PETERSBURG THROUGH ROUTE, PHASE II

P.F.I. CANNERY TO PINE STREET

GRADING, DRAINAGE, & PAVING

AS-BUILT PLANS

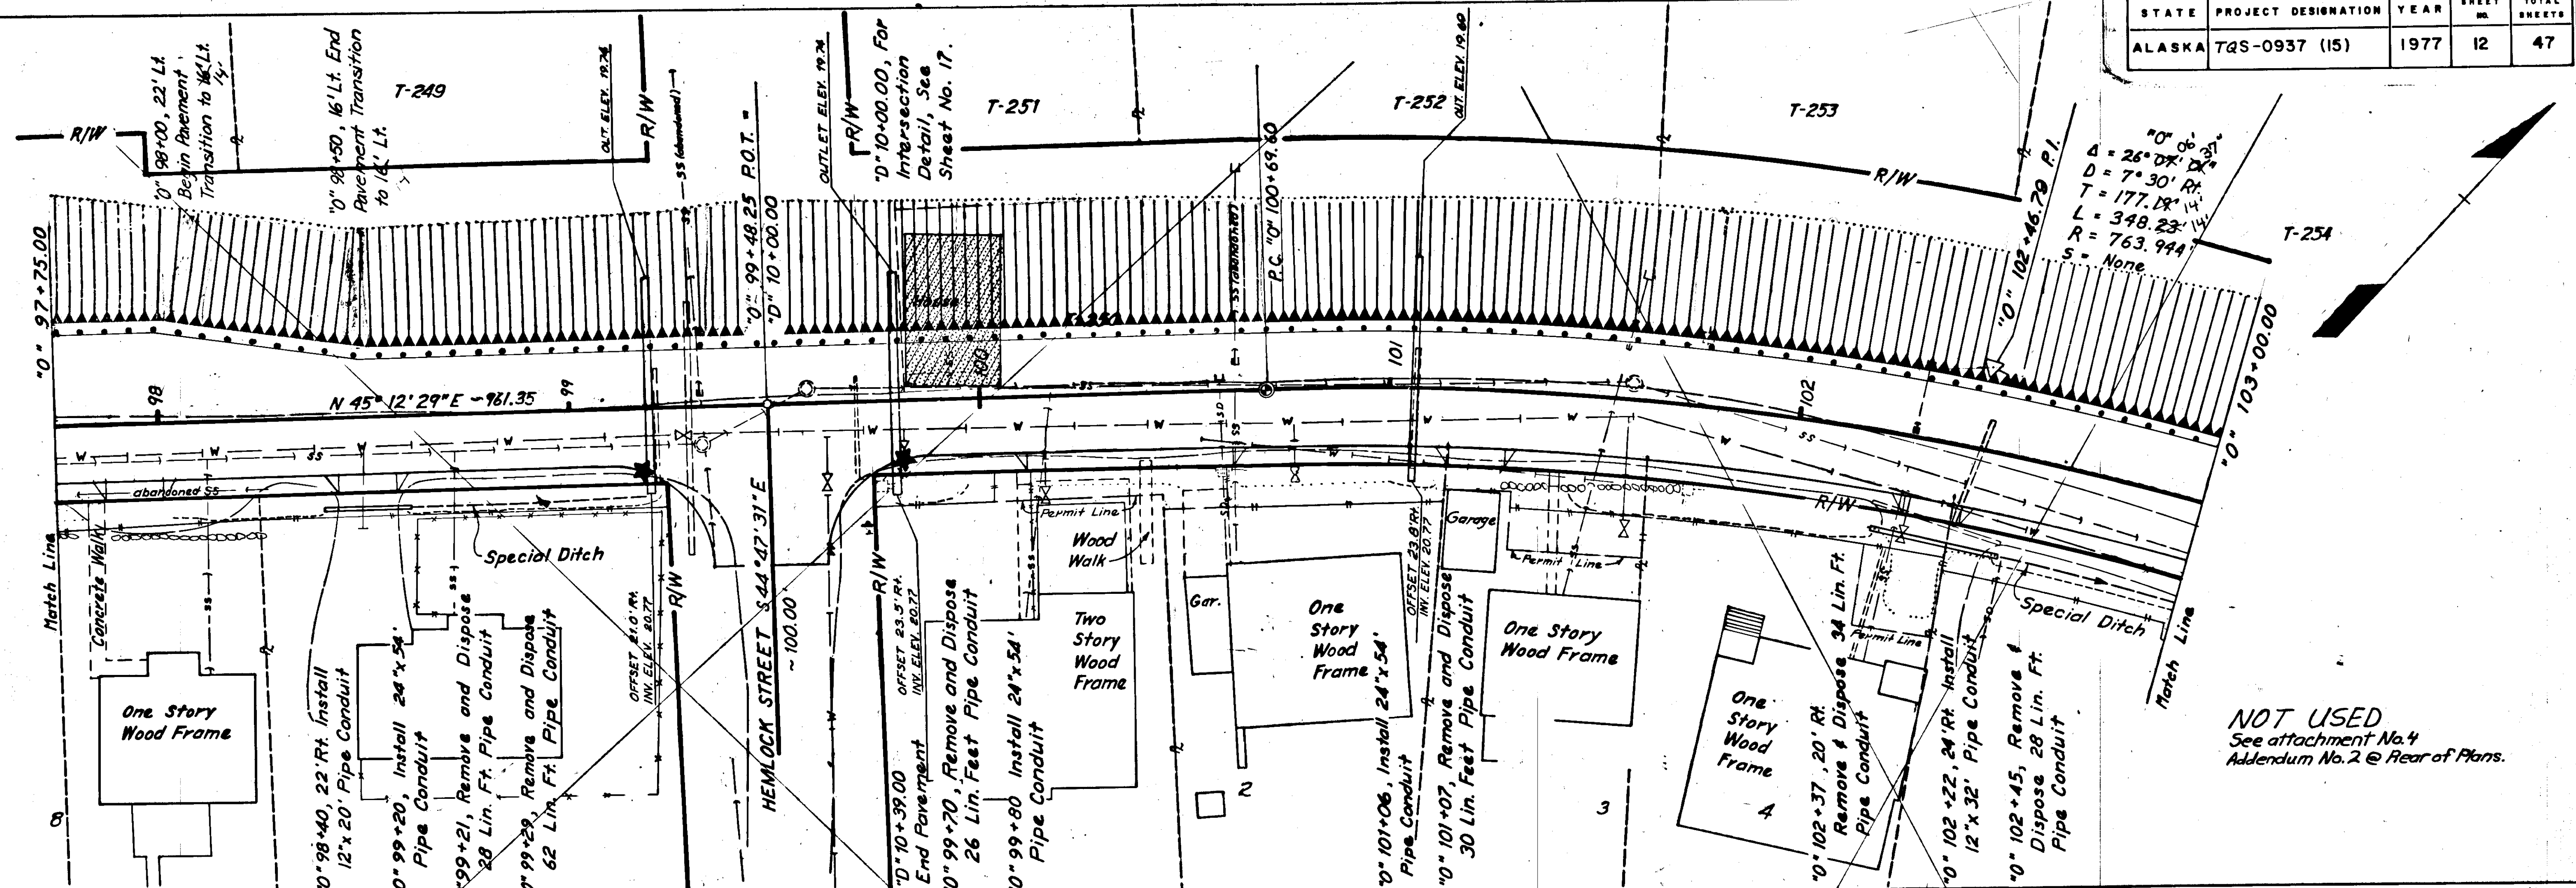
NOT USED
See attachment No.4
Addendum No.2 @ Rear of Plans.

CURB ALIGNMENT DETAILS & APPROACH DETAILS

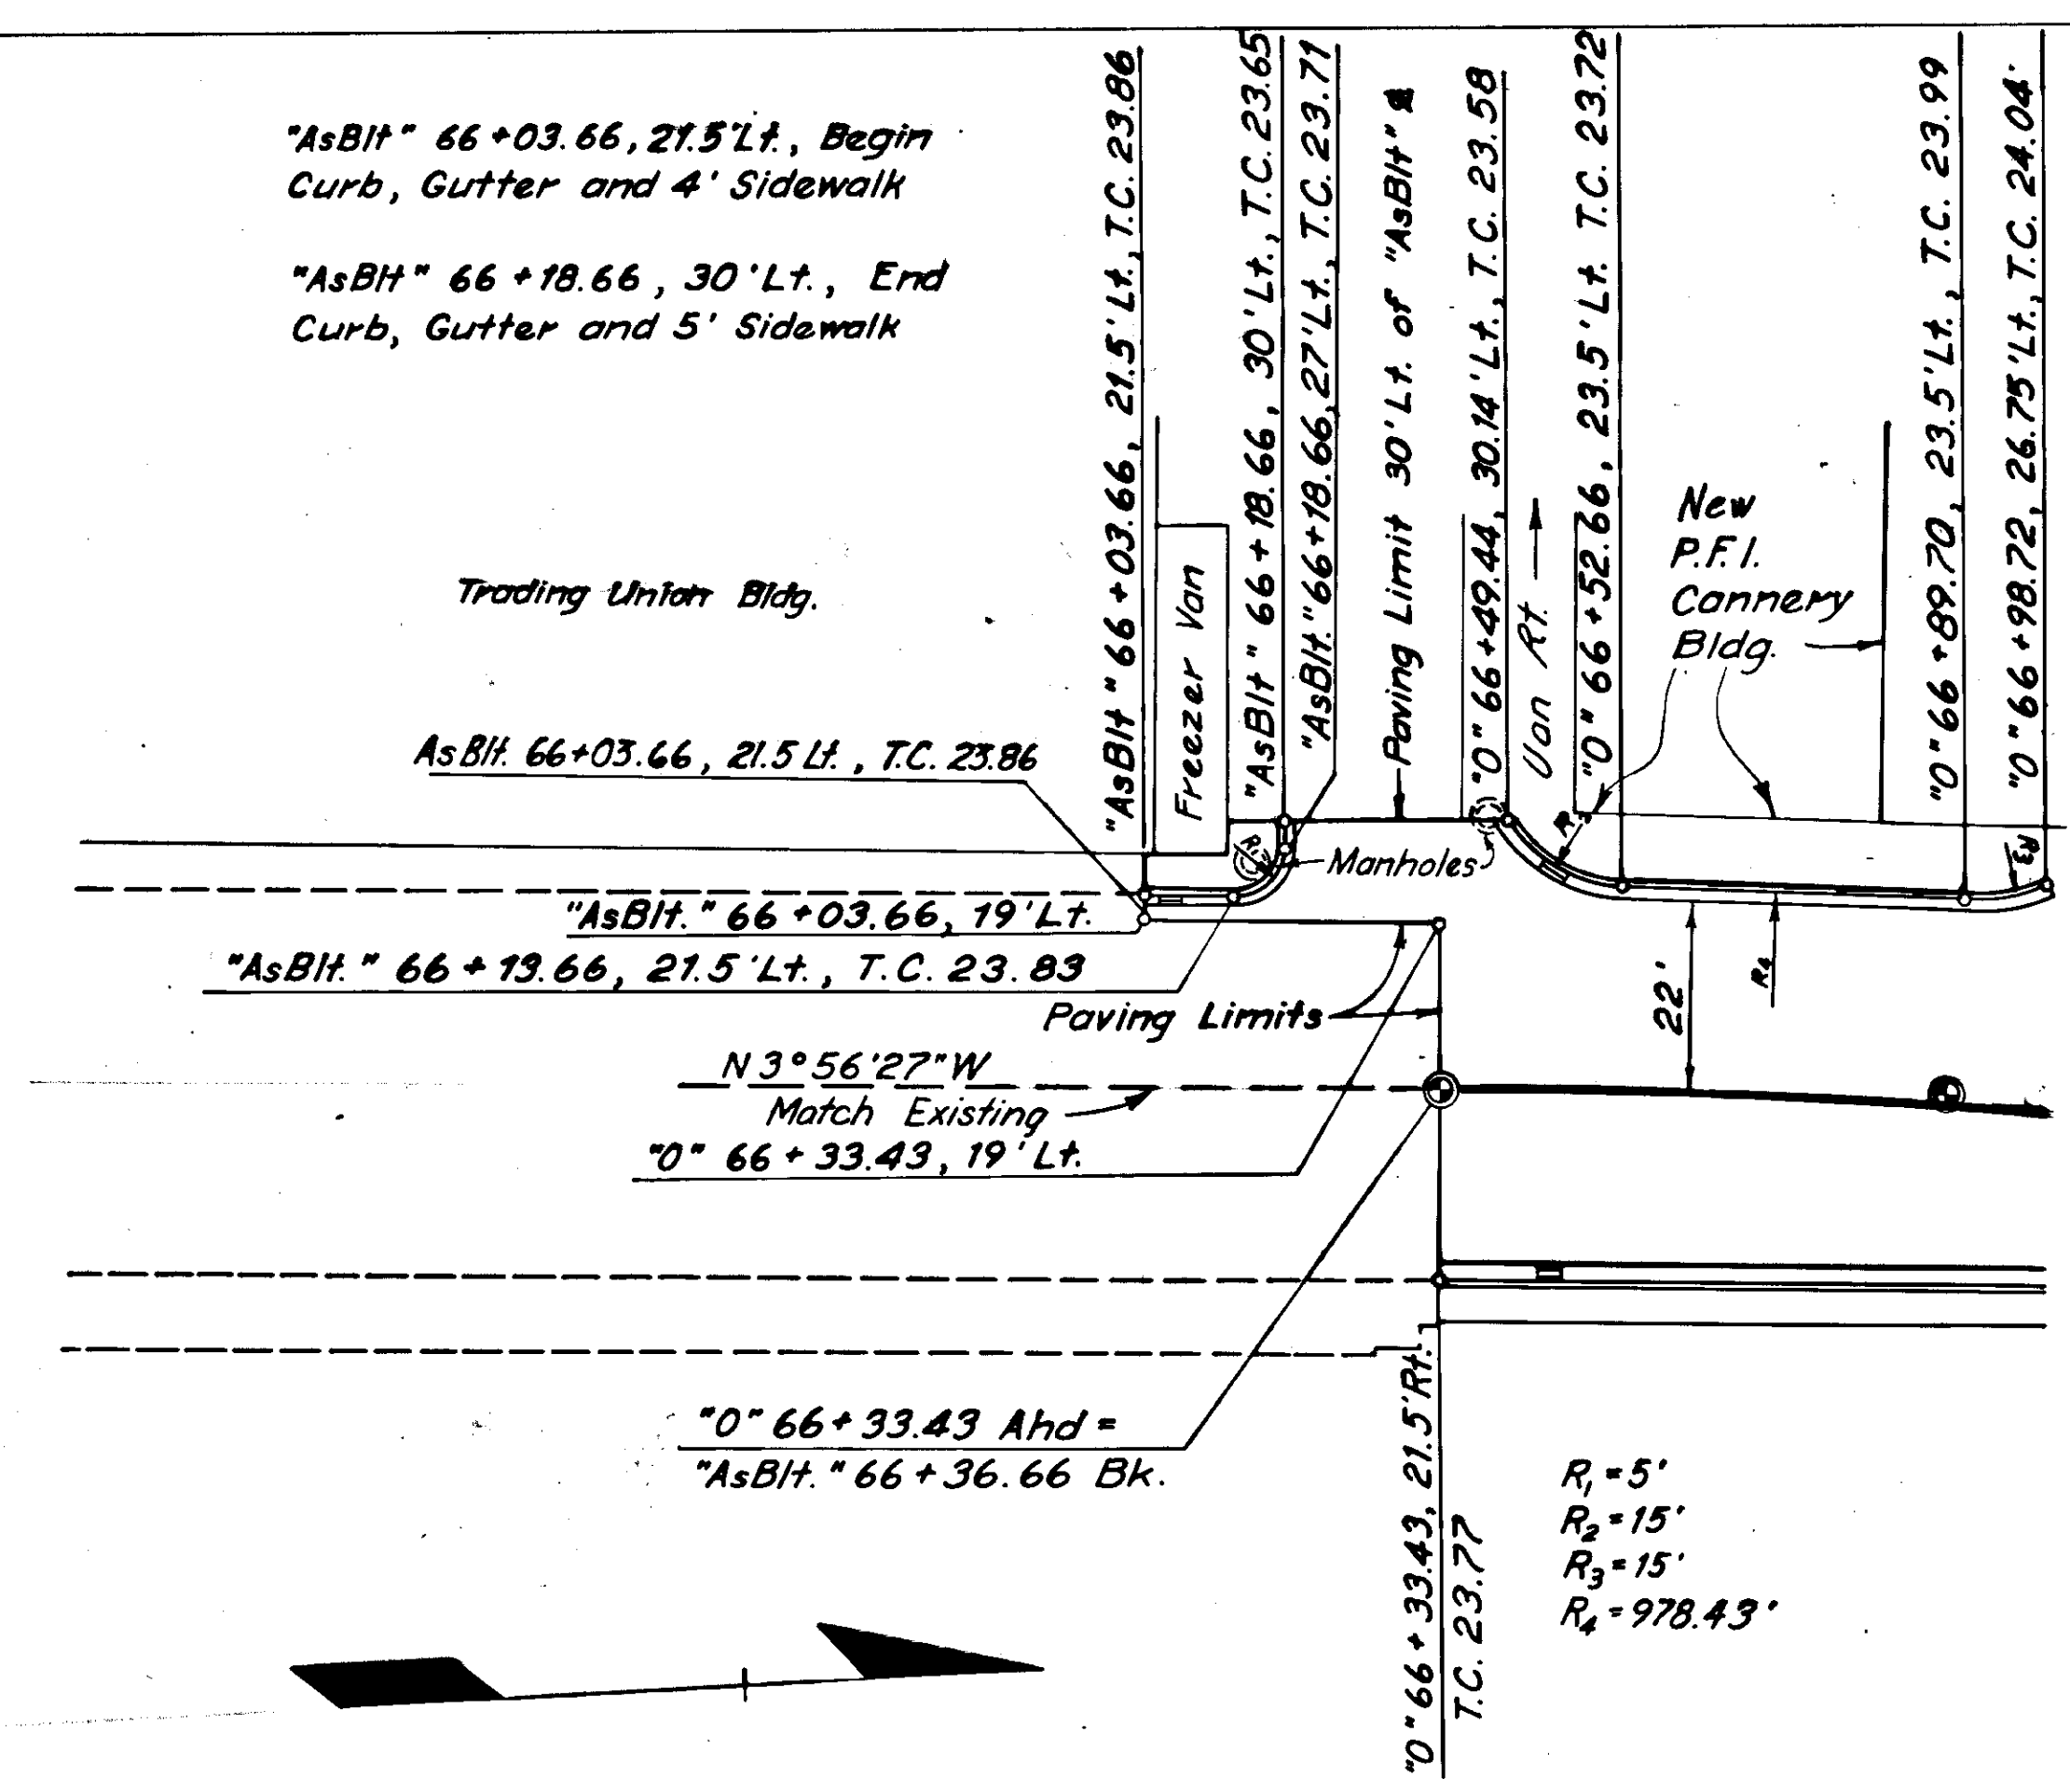
Constructed as shown
Changes in red are approx. only
